PROPOSED TECHNICAL SPECIFICATION CHANGES  
FOR DRESDEN 2

## 1.1 SAFETY LIMIT

## 2.1 LIMITING SAFETY SYSTEM SETTING

FIGURE 2.1-3  
(SCHEMATIC)APRM FLOW BIAS SCRAM RELATIONSHIP  
TO NORMAL OPERATING CONDITIONS

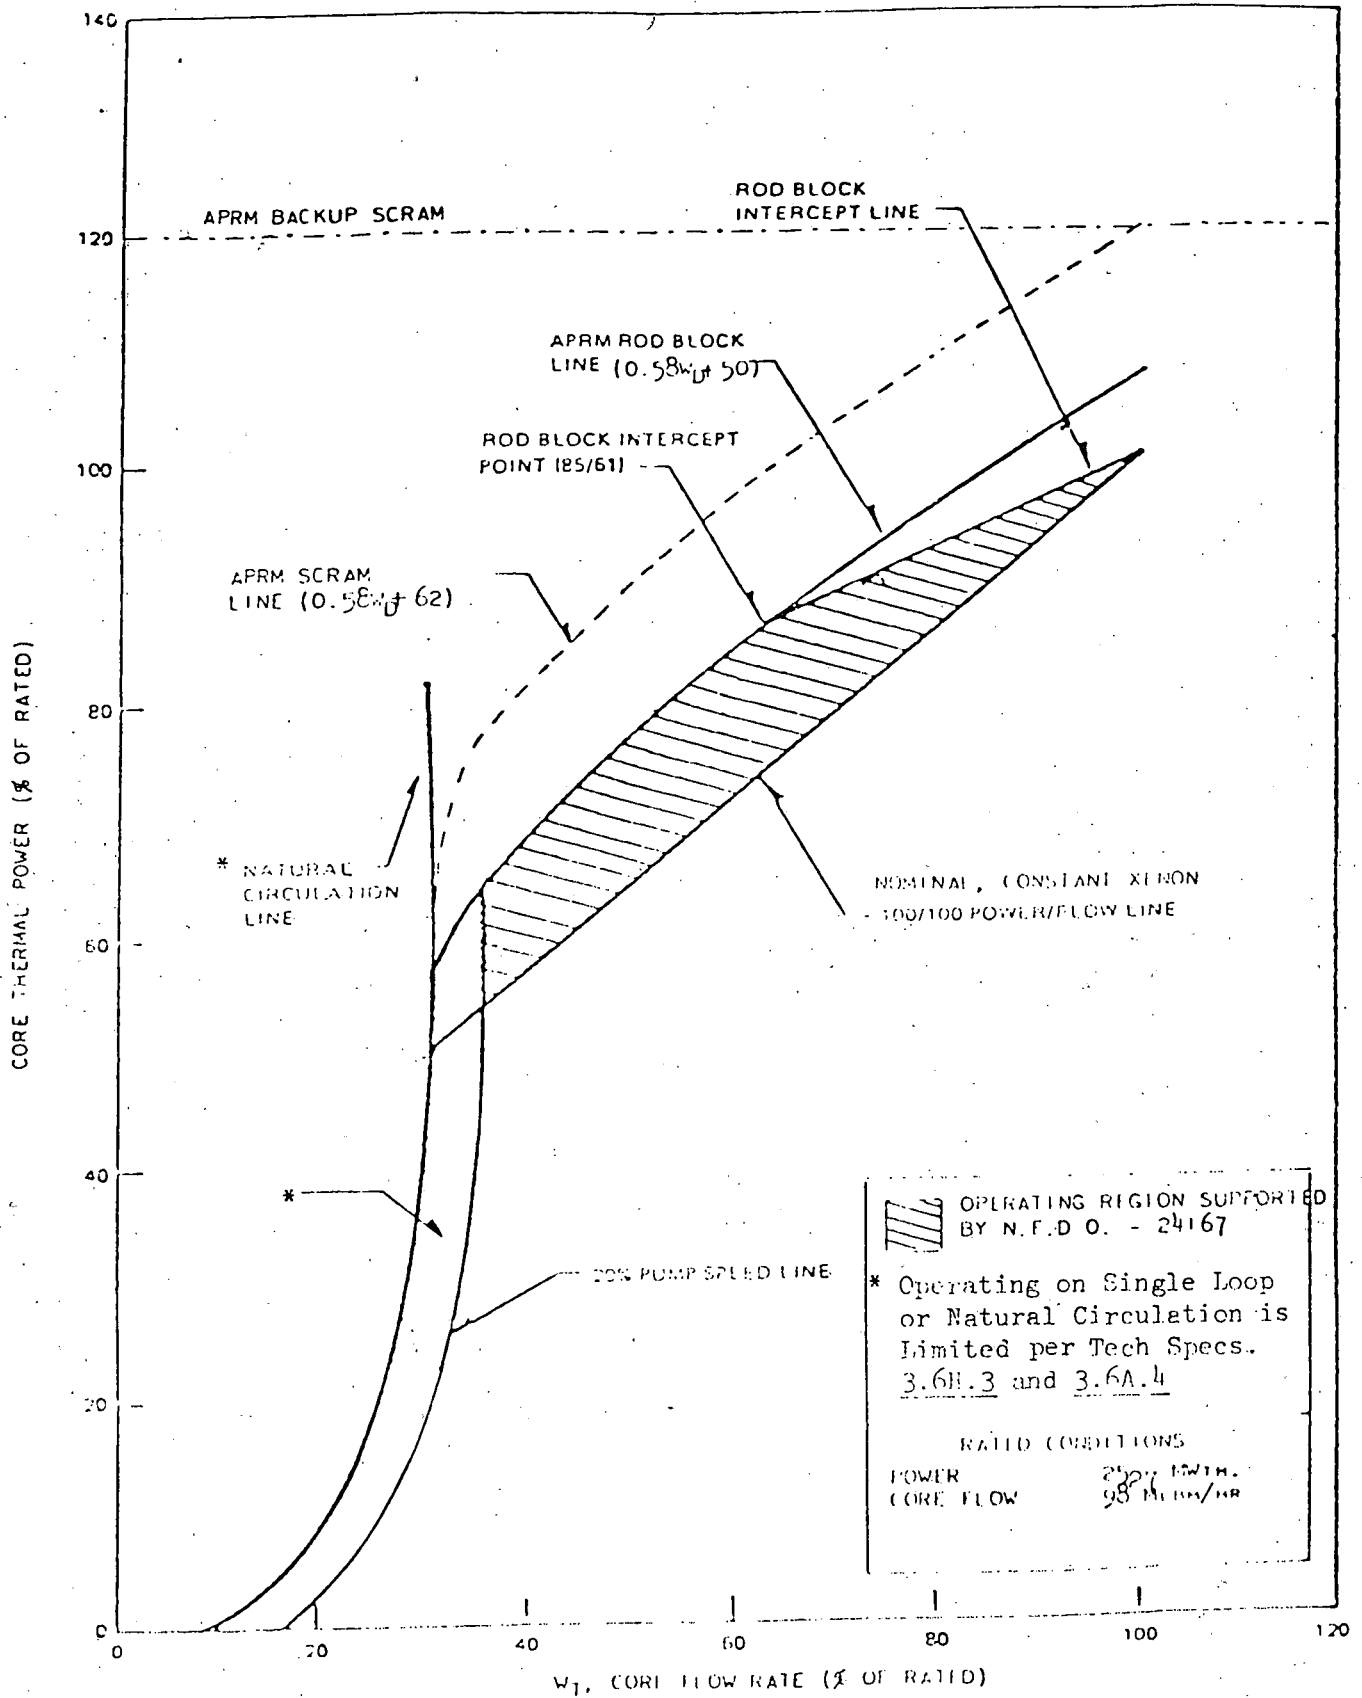
$$S \leq \left[ 0.58W_D + 62 \right] \left[ \frac{LTPF}{TPF} \right]$$

with a maximum set point of 120% for core flow equal to  $98 \times 10^6$  lb/hr and greater.

TPF - LTPF unless the combination of power and peak LHGR is above the curve in Figure 2.1-2 at which point the actual peaking factor value shall be used.

LTPF = 3.05 (7x7 fuel assemblies)  
 3.01 (8x8 fuel assemblies)  
 2.98 (8x8 R fuel assemblies)

$$S \leq \left[ 0.58W_D + 50 \right] \left[ \frac{LTPF}{TPF} \right]$$
